Enquiries: Neil Beck
Our Ref: OP 2023_5438/1 (1168266)
Your Ref: 026-2201

CONFIRMATION NOTICE & INFORMATION REQUEST

Application Number: OP2023_5438/1
Approval Sought: Development Permit
Nature of Development Proposed: Operational Works
Description of the Development Proposed: Operational Works (Ocean Breeze Estate - Stages 3A2 and 3B)

Figure 1: Cross section of batter

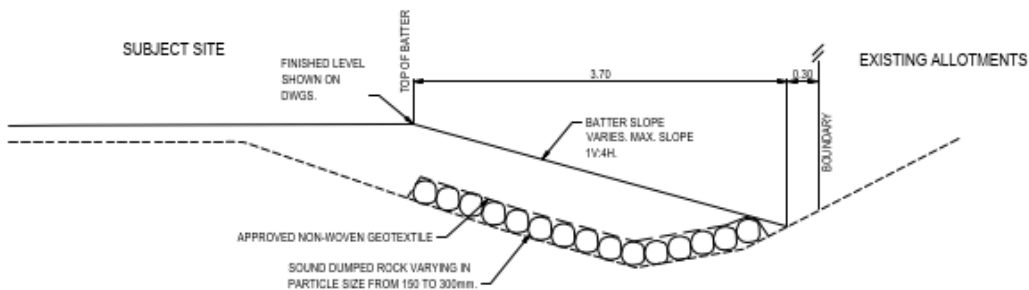
1. Clarification is required for the treatment and ongoing operation of the drainage path along the eastern boundary of lots 7 to 16 in particular.

- a. Concern is raised with the resulting drain invert now shown as being offset 0.3 m from the property boundary compared to the existing offset of approximately 2 m. The applicant is to demonstrate how the invert will be protected and not filled over by future owners.

- b. Confirm that there is no adverse flooding impact to existing properties along the boundary due to flow within this drain being reduced.
- c. Clarify how the resulting drainage path will drain freely given that the levels provided in the Civil Engineering Drawings indicate sag points along the boundary of the development and existing Lots. The applicant is to demonstrate how free draining conditions will be maintained.

- d. Confirm that the slope of the batter at the rear of Lots 7 to 16 along the eastern boundary of the development maintains the maximum slope of 1 in 4 as detailed in the Civil Engineering Drawings (maximum slope of 1 in 4 as stated in the typical cross section provided; see figure 1).

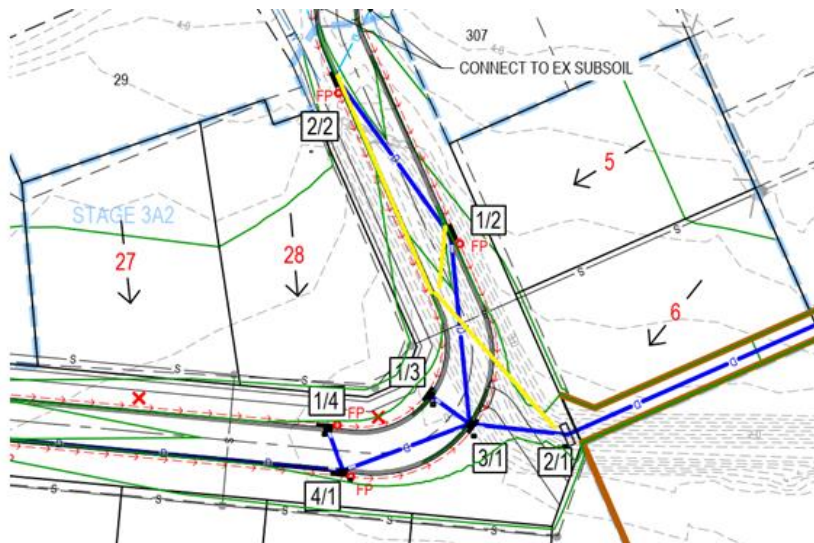
2. The proposed grade of Road F between the Chainages 75 to 251.124 is shown in the Longitudinal Section provided as being graded to 0.3%. Reference is made to FNQROC D1.06 which states that road "A general minimum gradient of 0.5 per cent should be adopted for all roads, which will ultimately include kerb and channel. In very flat conditions where approved by Council it may be reduced to 0.3 per cent." The applicant is requested to clarify the reasons for the reduction to the minimum 0.3% grade. For the 0.3% road grade, the capacity of the road to convey the Major event flows is to be confirmed.

Figure 2: Cross Section of Twin 1050 RCPs between Manhole 2/1 and 1/1

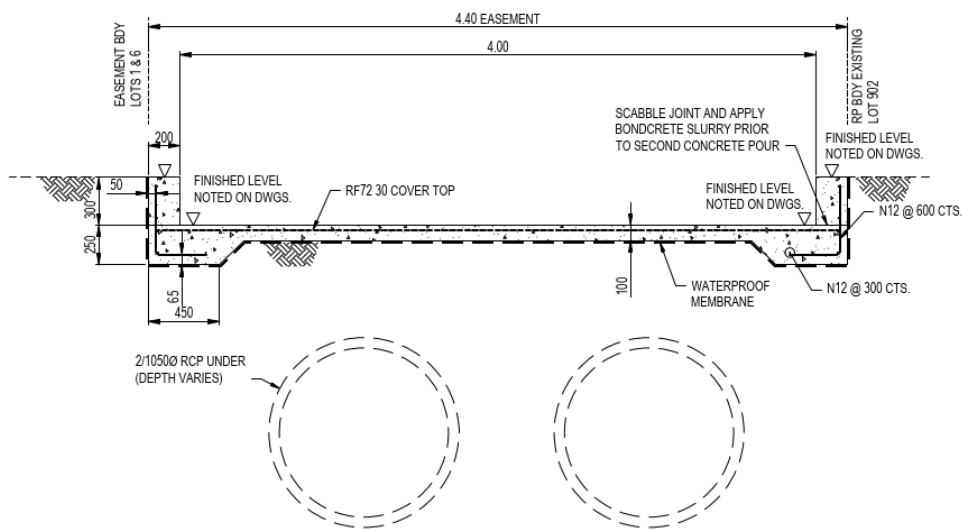
10. Extend concrete footpath to the head of the cul-de-sac and increase width to 2m.
11. With reference to the cross section (in Figure 2 below) for the twin 1050 RCPs between Manhole 2/1 and 1/1. The applicant is to confirm the zone of interference for the RCPs and demonstrate that there is no impact on the above infrastructure. The applicant is to confirm the zone of impact for the RCPs and demonstrate that there are no restrictions on adjacent lots and/or no impact to replacement of pipes in the future. The depth of the RCPs are not provided on the cross section to determine zone of influence.
